New Bid Date and Time 3:00 PM, Wednesday, May 30, 2012

ADDENDUM 2

Project Name: **Hale Stadium Renovations
Tennessee State University**
Owner: **Tennessee Board of Regents**
Address: **Office of Facilities Development
Suite 664 (6th Floor, southwest) Genesco Office Park
1415 Murfreesboro Road
Nashville, TN 37217-2833**
City, State:
Project Number **SBC #166/002-02-2011
HFR# 2011171.00**
Date: **May 18, 2012**
From: **HFR Design, Inc.
7101 Executive Center Drive, Suite 300
Brentwood, TN 37027**

SITE
DEMOLITION
PLAN
NORTH
ENTRY

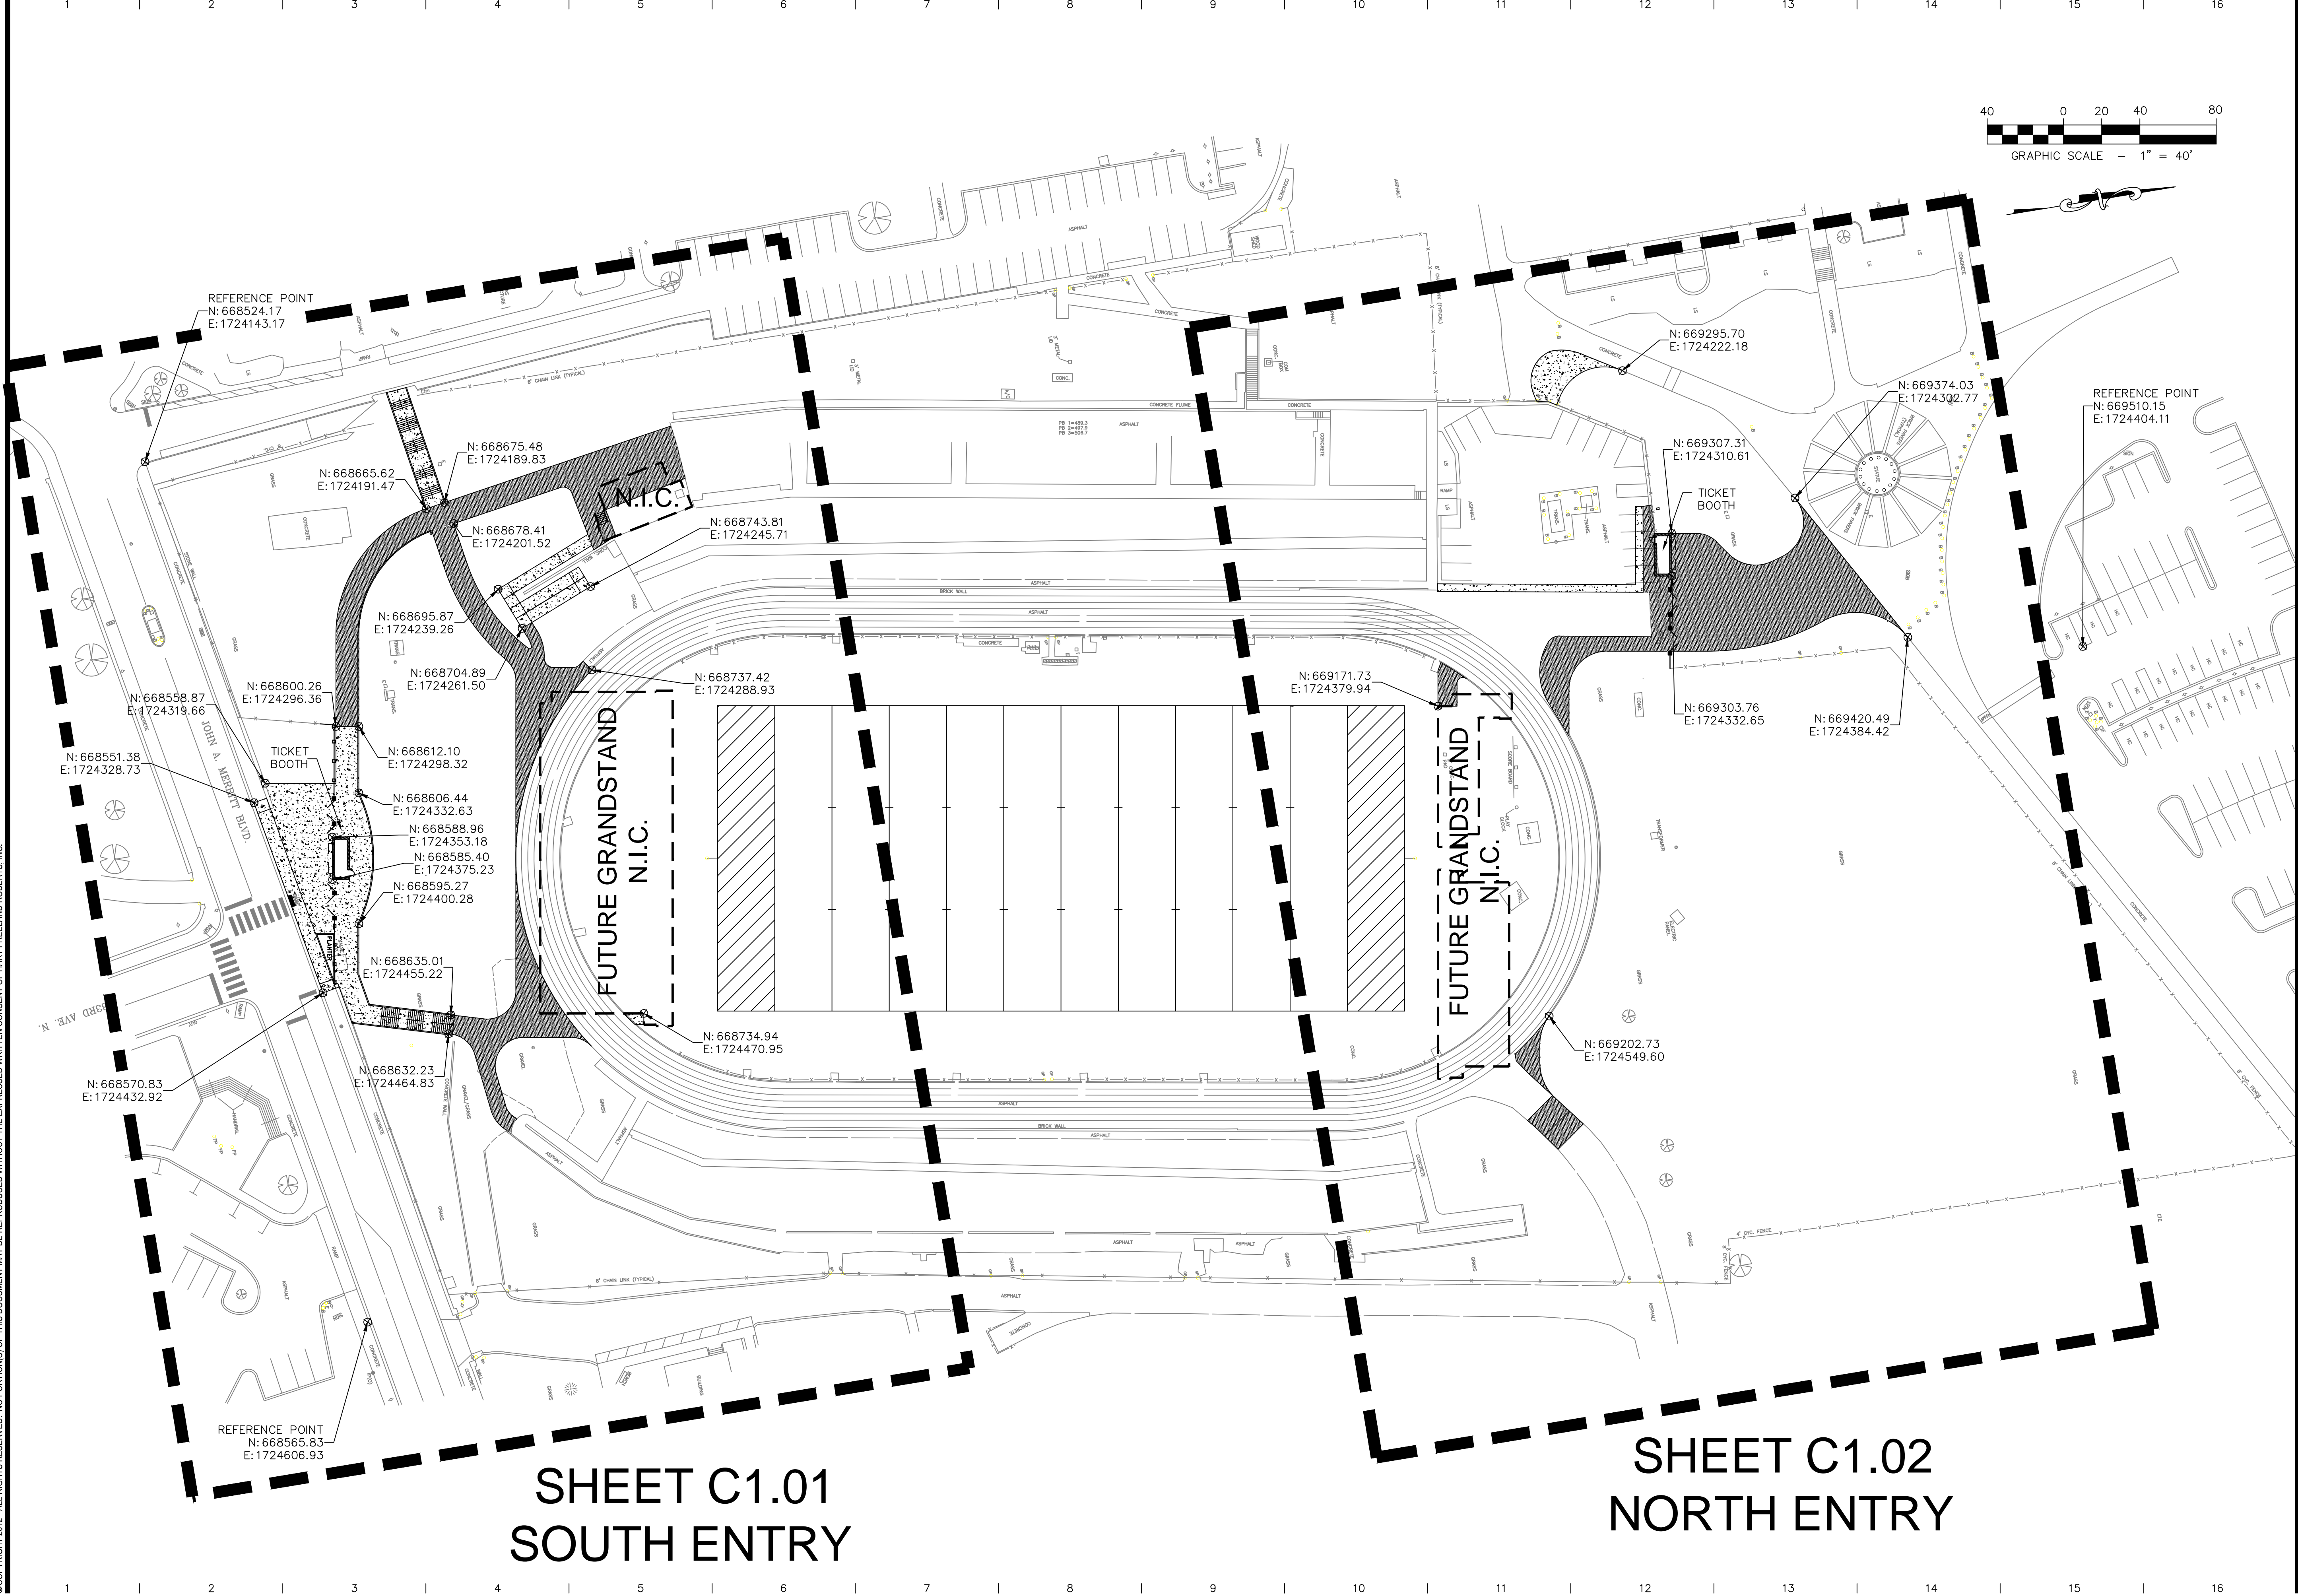
- 2-11. Drawing C0.03: Delete note for removal of existing poles.
- 2-12. Drawing C0.04:
 - A. Add removal of pavement to driveway north of the east grandstand to accommodate electrical trenching and repair of pothole.

- B. Add the removal of the existing 18" CMP in the bio-retention area.
- 2-13. Drawing C1.01:
 - A. Delete gate at top of access driveway, add post with chain per detail.

C1.01

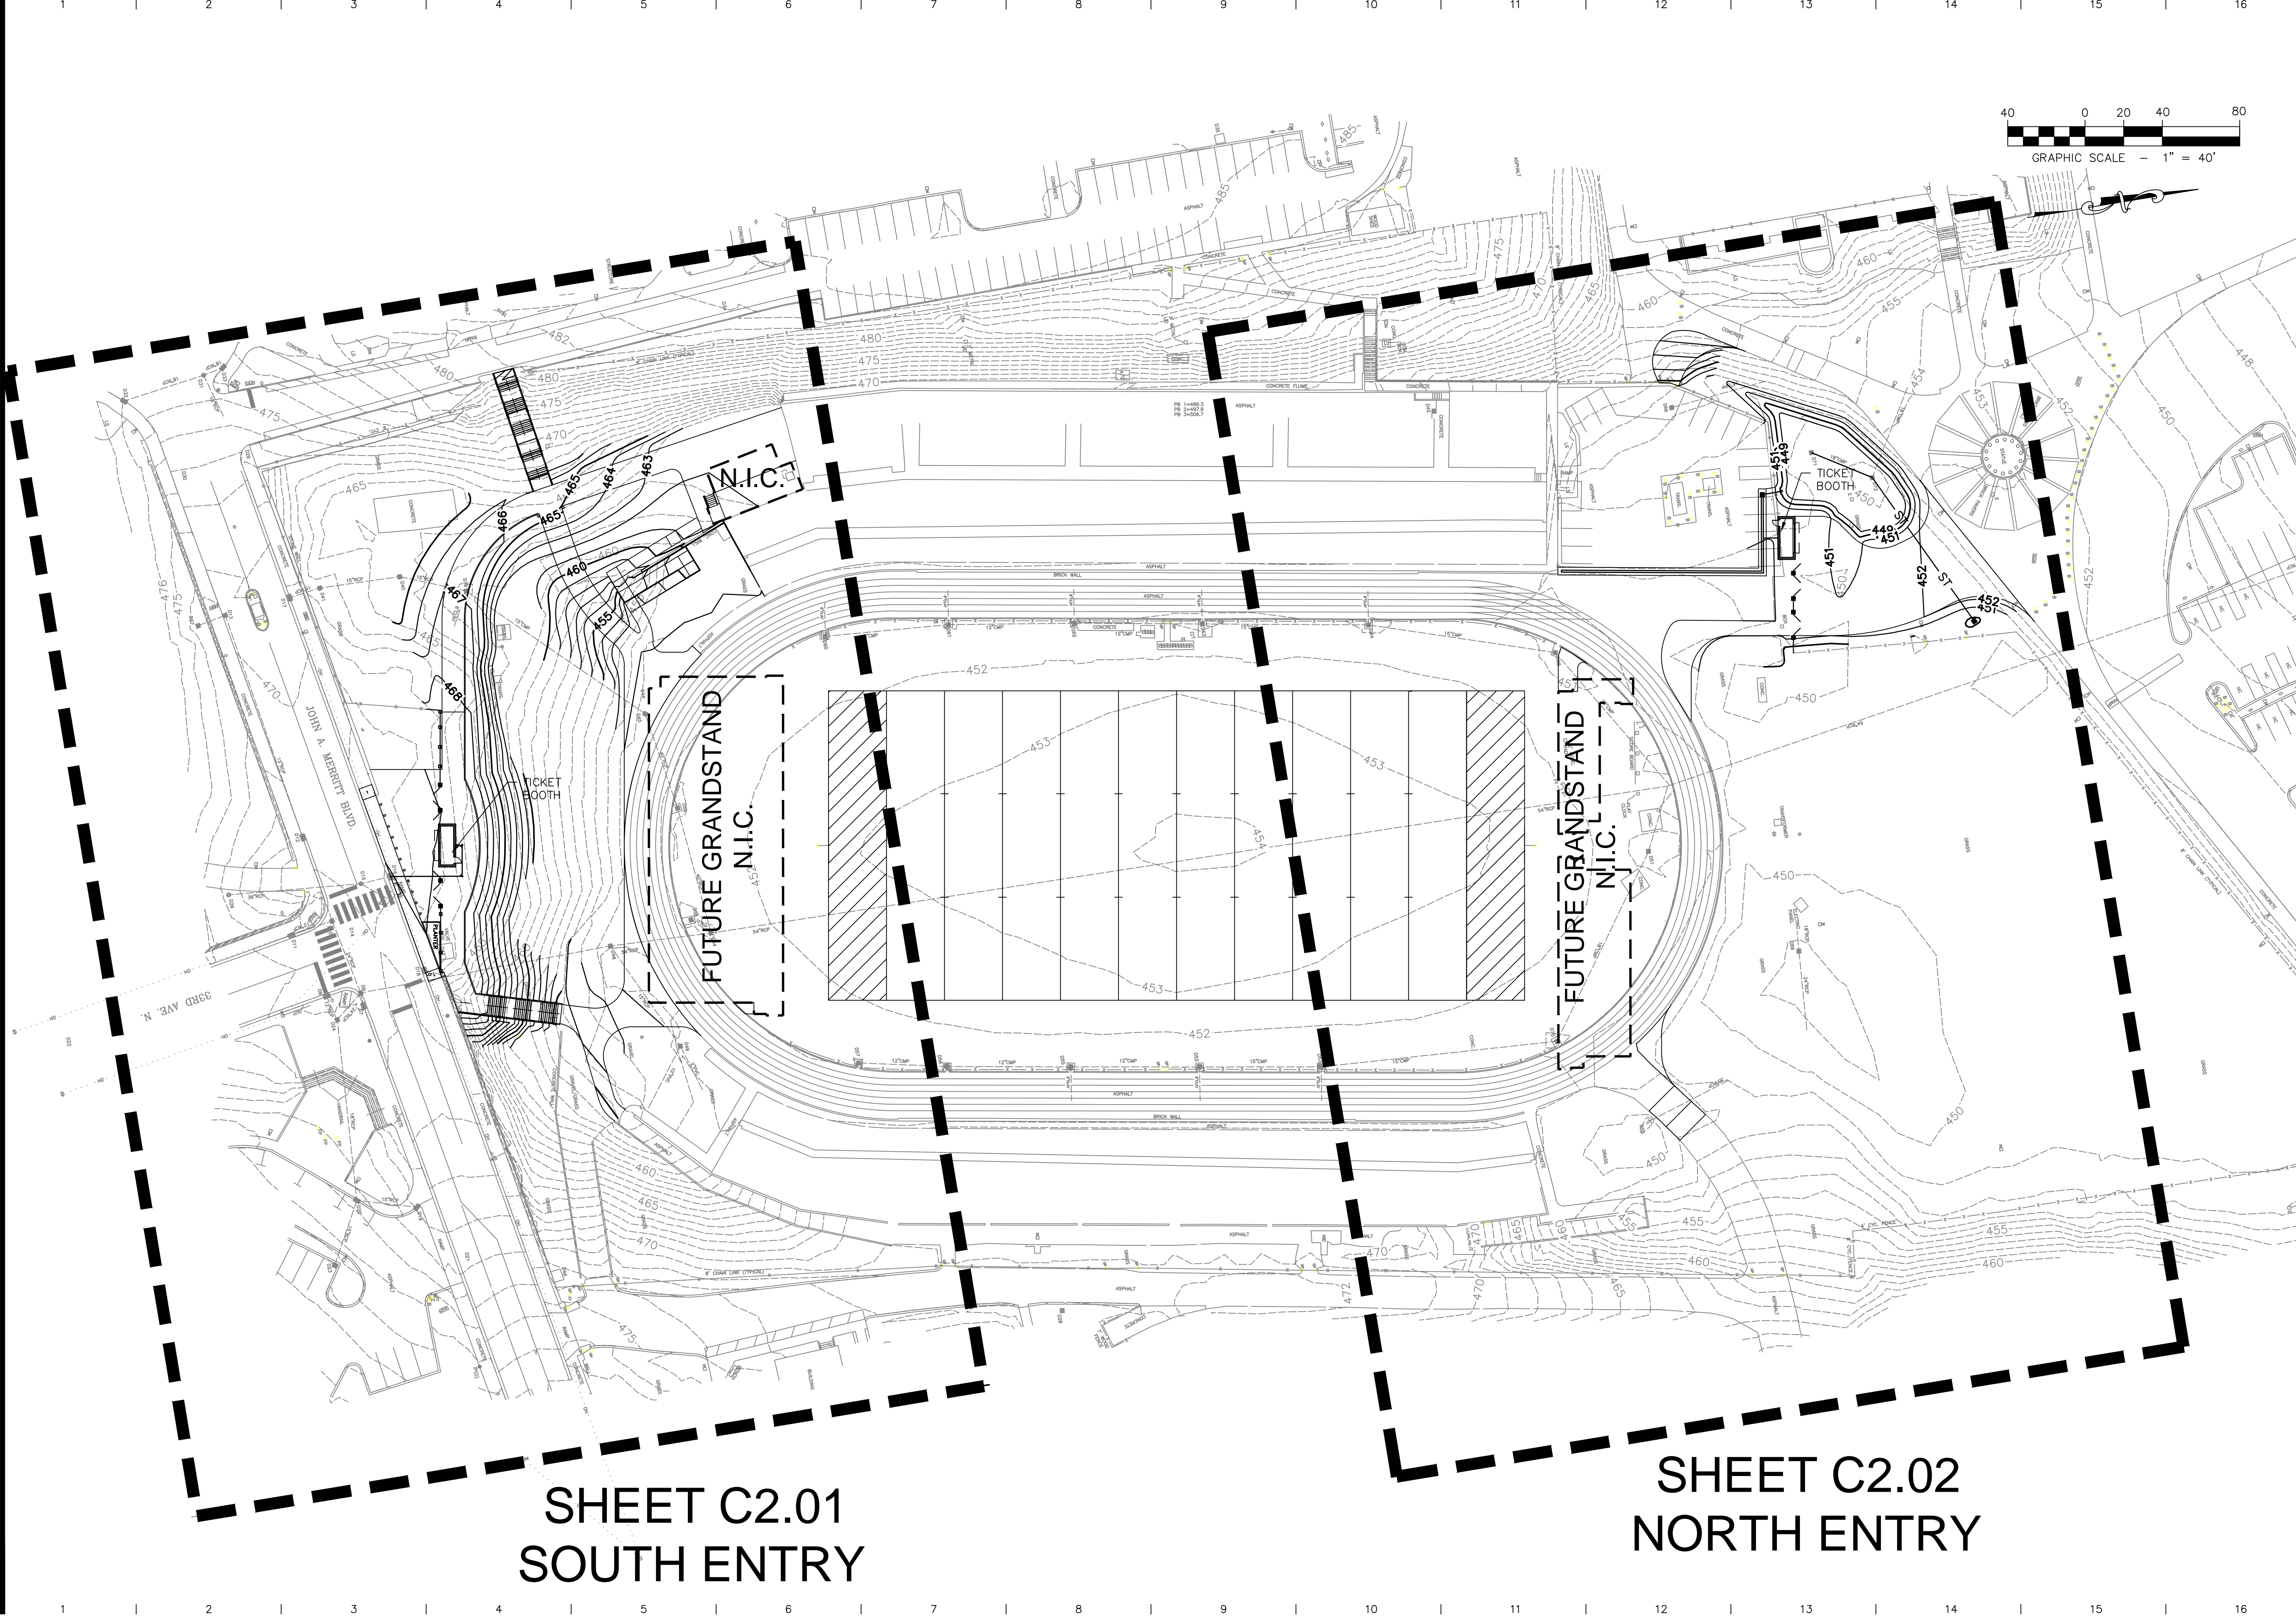
- B. Add detail callout for stone column
 - C. Revised the detail callout for the removable bollards.
- 2-14. Drawing C1.02:
 - A. Add trench repair and asphalt overlay to driveway north of the east grandstand.

GRADING &
DRAINAGE
PLAN NORTH
ENTRY

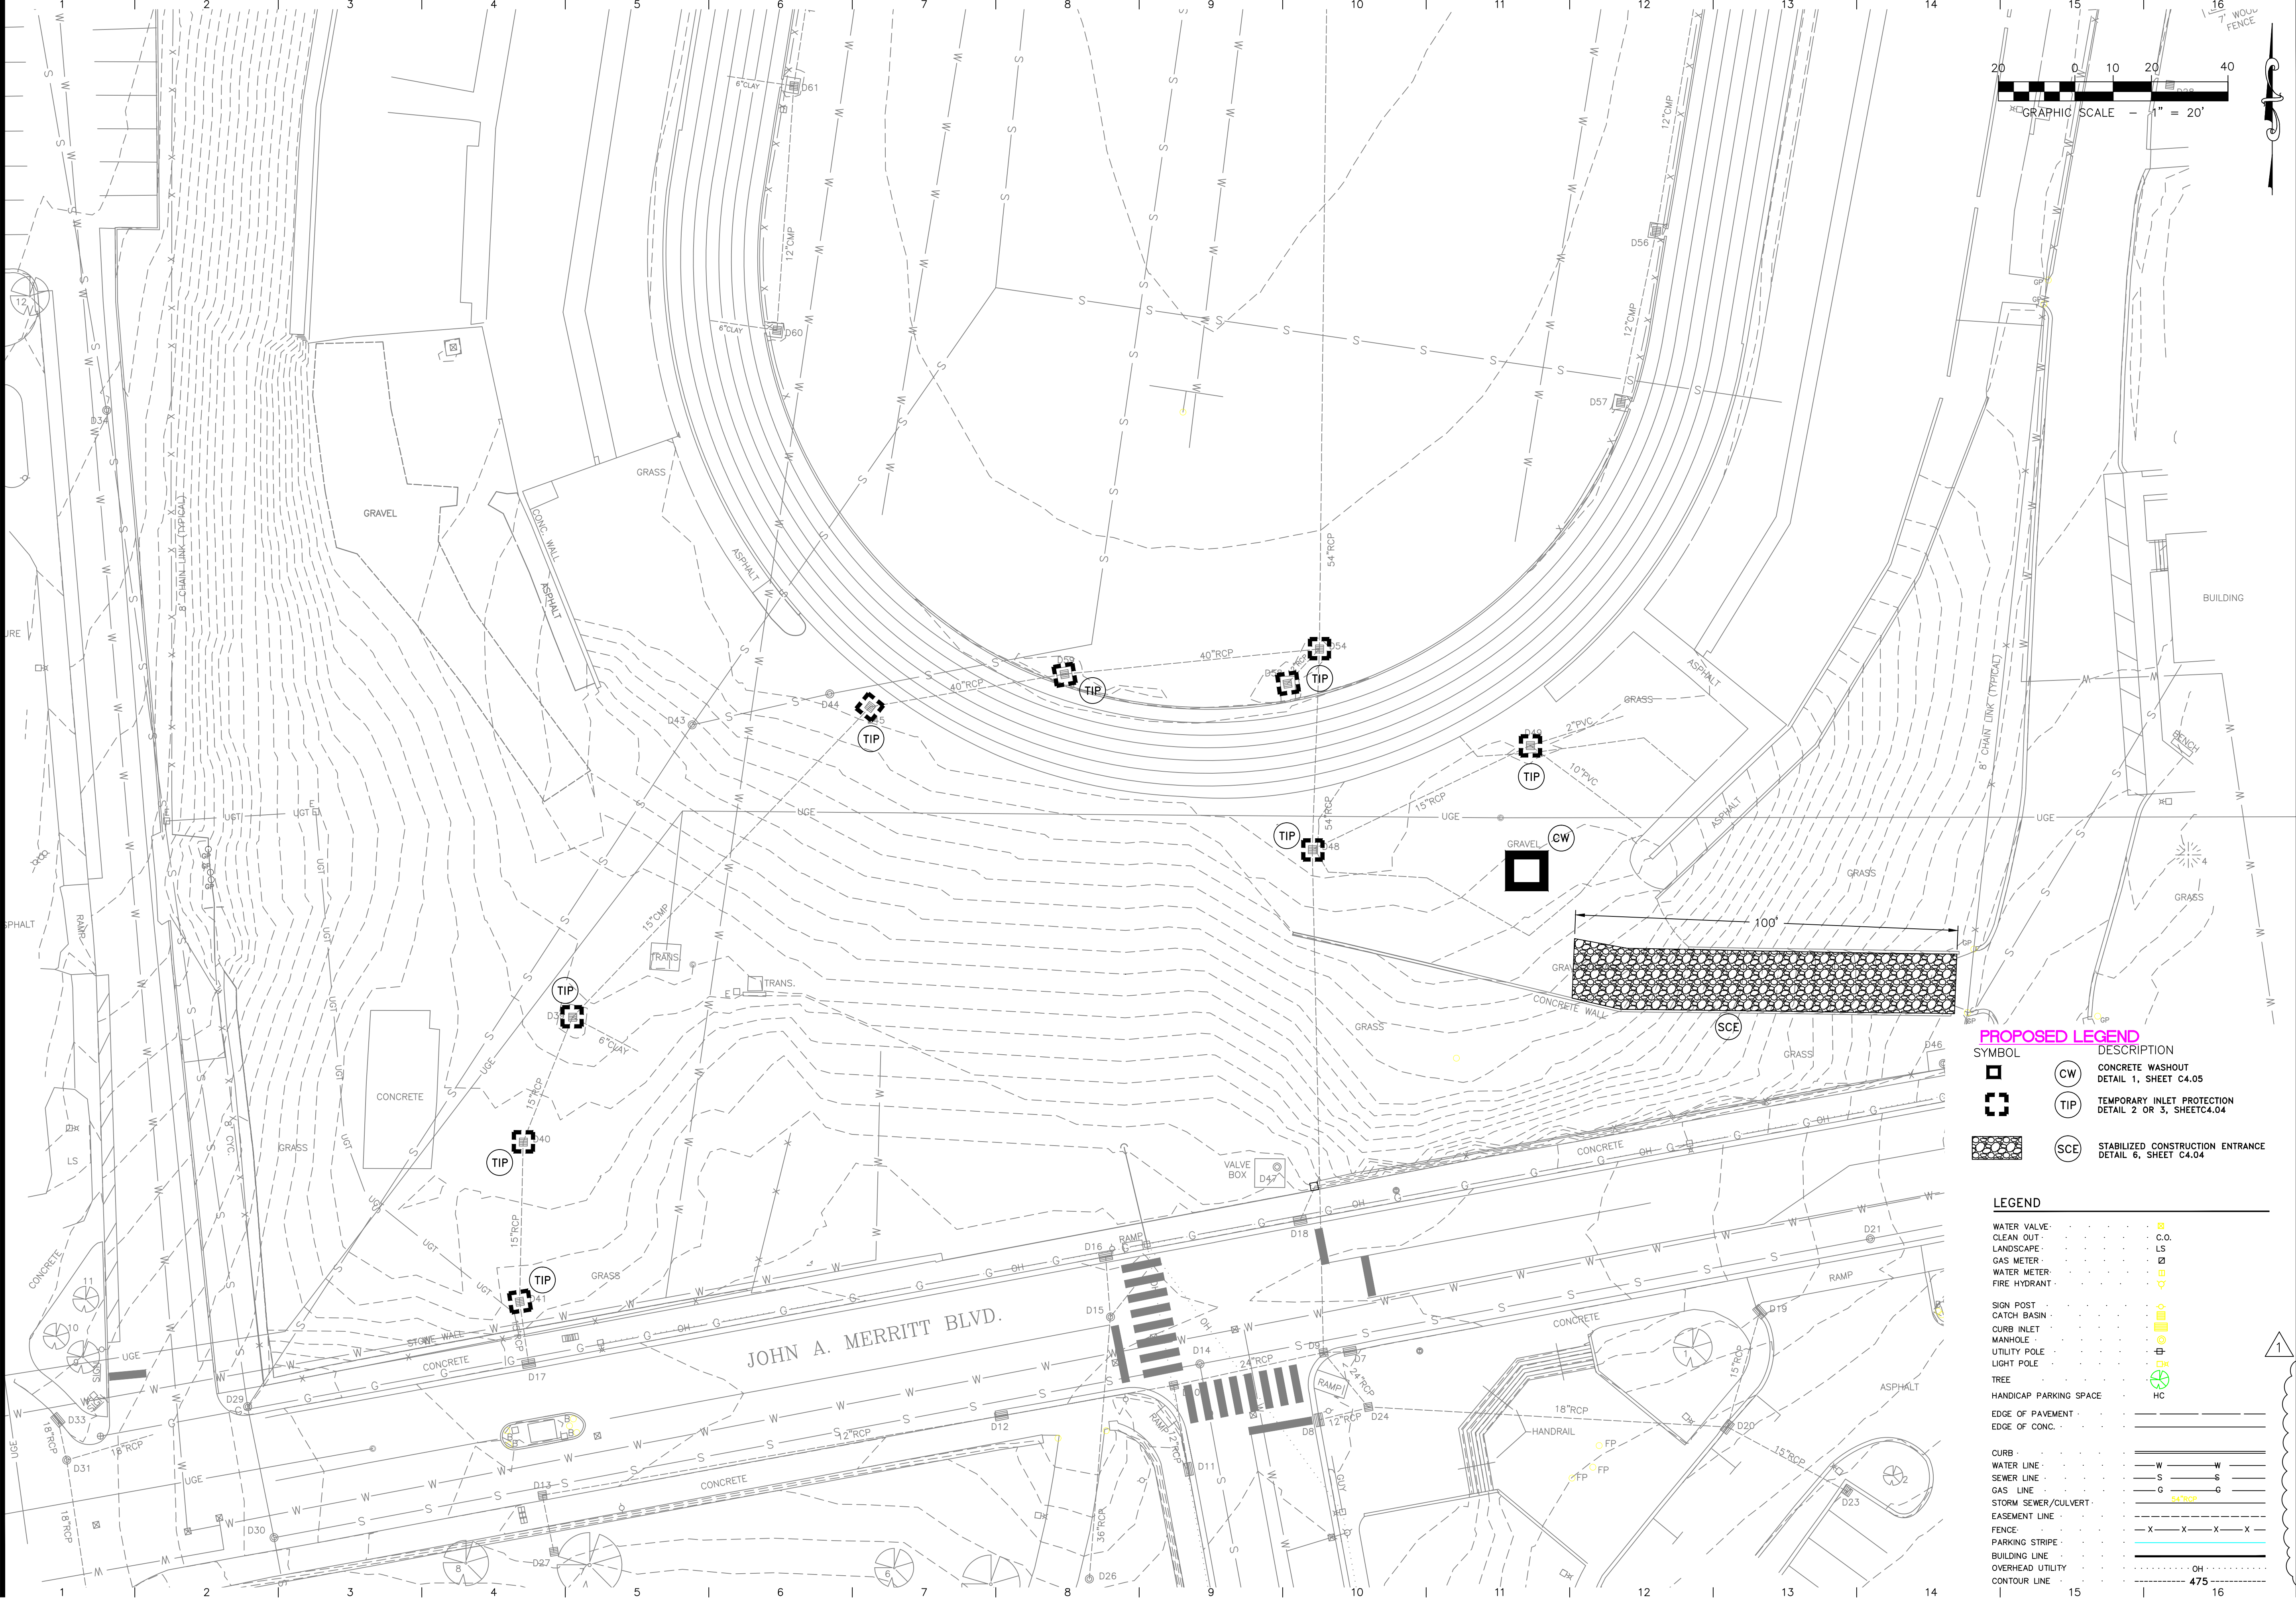
- 2-16. Drawing C2.02: Revised limits, grading and added 12" perforated pipe for bio-retention area.
- 2-17. Drawing C2.03: Added sheet.
- 2-18. Drawing C2.04: Added sheet.
